Well Name: SD WE 15 FED P9	Well Location: T26S / R32E / SEC 15 / SESE / 32.035506 / -103.658475	County or Parish/State: LEA / NM
Well Number: 5H	Type of Well: OIL WELL	Allottee or Tribe Name:
Lease Number: NMNM118722, NMNM118723	Unit or CA Name:	Unit or CA Number:
US Well Number: 3002543640	Operator: CHEVRON USA INCORPORATED

Notice of Intent

Type of Submission: Notice of Intent	Type of Action: Plug and Abandonment
Date Sundry Submitted: 10/06/2025	Time Sundry Submitted: 09:48
Date proposed operation will begin: 10/27/2025

BLM Revised P&A Procedure

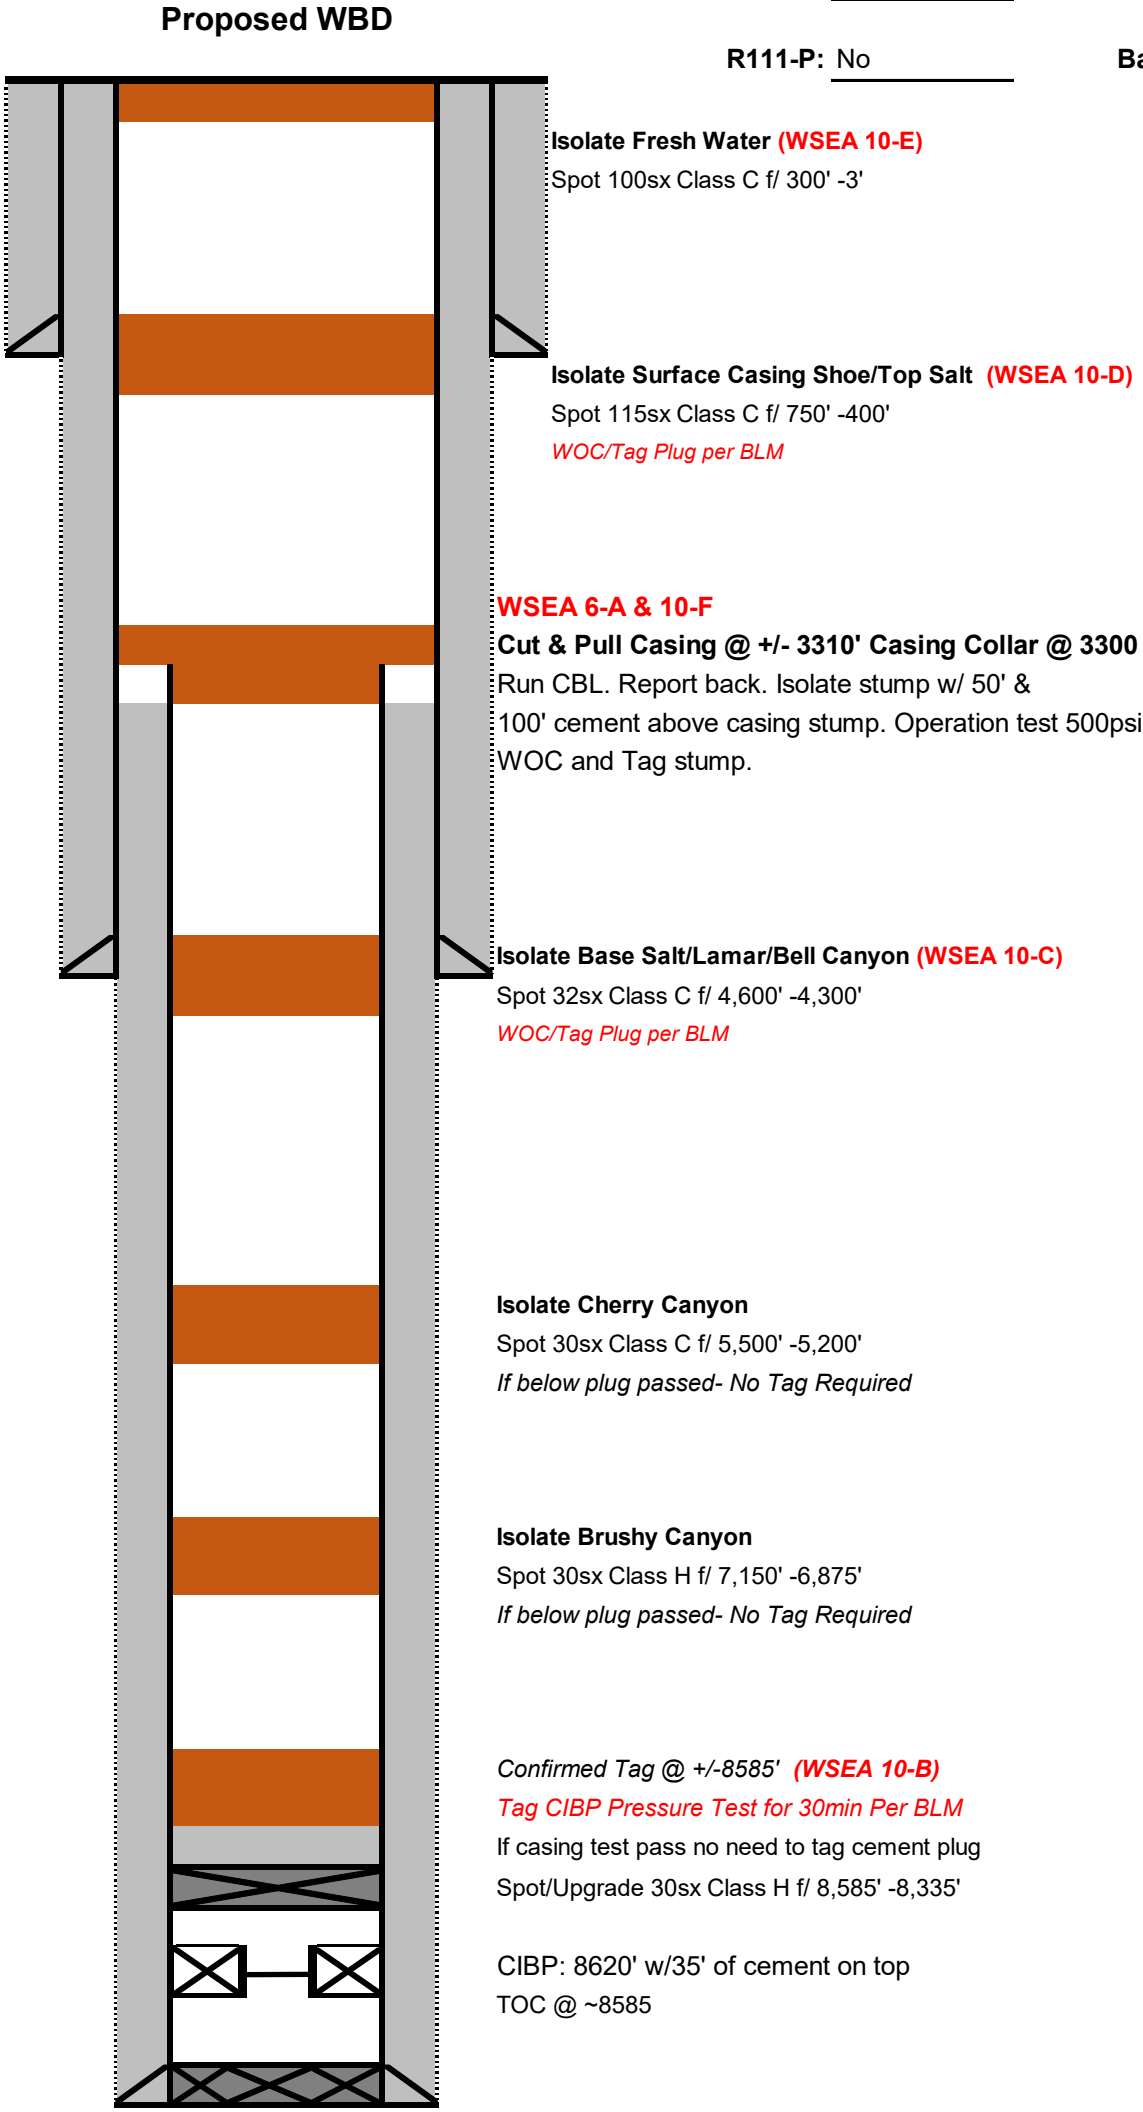
1. Notify BLM 24 hrs prior to starting operations.
2. MIRU WOR.
3. Check for pressure on tubing. Kill well if necessary.
4. NDWH & NU BOP. Release pkr & TOH w/ tbg.
5. RIH and tag previous plug at 8585'. Run CBL from 8585' to surface. Pressure Test.

Contact BLM after running CBL.

6. Spot 30 sx Cl H from 8585' – 8335'.
7. Spot 30 sx Cl C from 7150-6875'. **WOC and TAG (T/ Brushy Canyon)**
8. Spot 30 sx Cl C from 5500'-5200ft. (T/ Cherry Canyon)
9. Spot 32 sx Cl C from 4600'-4300. **WOC and TAG (T/ Delaware, Inter csg shoe, B/salt)**
10. Cut and pull casing at 3450ft. Spot Cl C cmt from 3500' to 3200'. **WOC and Tag.**
11. Spot 115 sx Cl C from 750' -400'. **WOC and Tag. (T/Salt, Surface shoe)**
12. Spot 100 sx Cl C from 300' to surface.

Install Dry hole marker.
